Criteria & Implementation Procedures for Valley & Stream
Corridor Regeneration and Remedial Works Projects

Toronto and Region Conservation Authority (TRCA) has commenced a study regarding the development of alternatives to remediate slope erosion located on Black Creek adjacent Troutbrooke Drive in the City of Toronto. The project is being considered in order to provide protection for nine residential properties which currently are at risk.

Troutbrooke Slope Stabilization Project
Class Environmental Assessment

Option 3: Remove Existing Fill & Replace with an Engineered Mechanically Stabilized Earth Wall

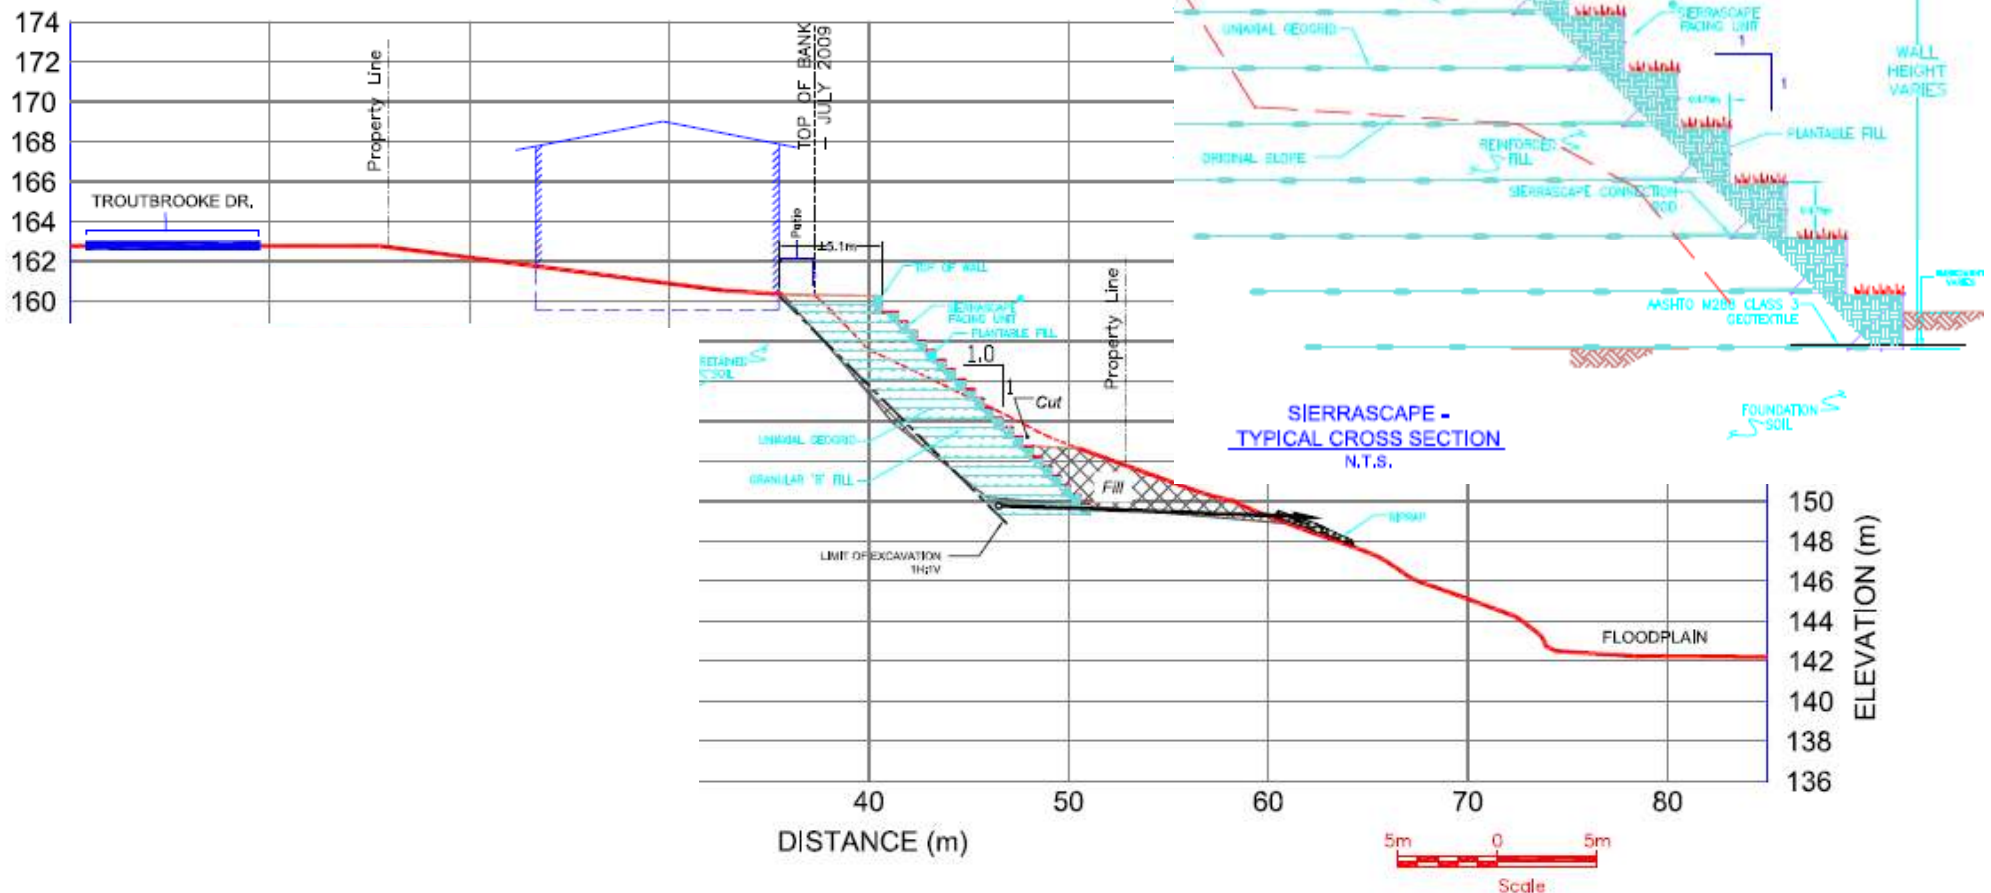
- once again this only presents a partial remedy to correct the problem.
- the homeowner will still lose value and full use of the property
- we would consider a wall at the end of the property line and have the slope begin from there

Option 3: Remove Existing Fill & Replace with an Engineered Mechanically Stabilized Earth Wall

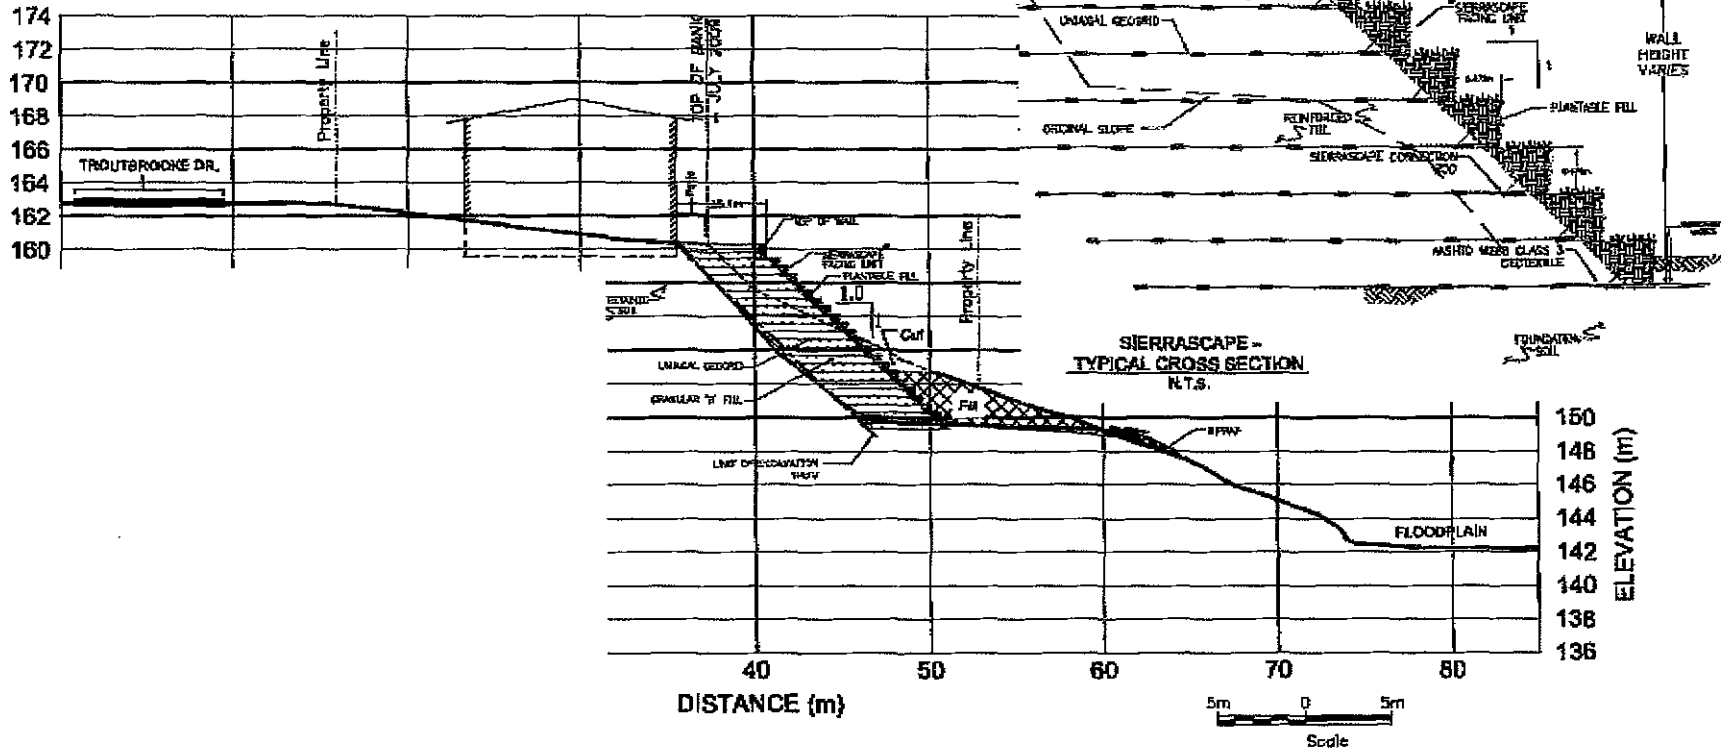
*This option is acceptable, however,
if you could add an additional
10 feet to the patio, to make it 25 feet,
that would be even better.*
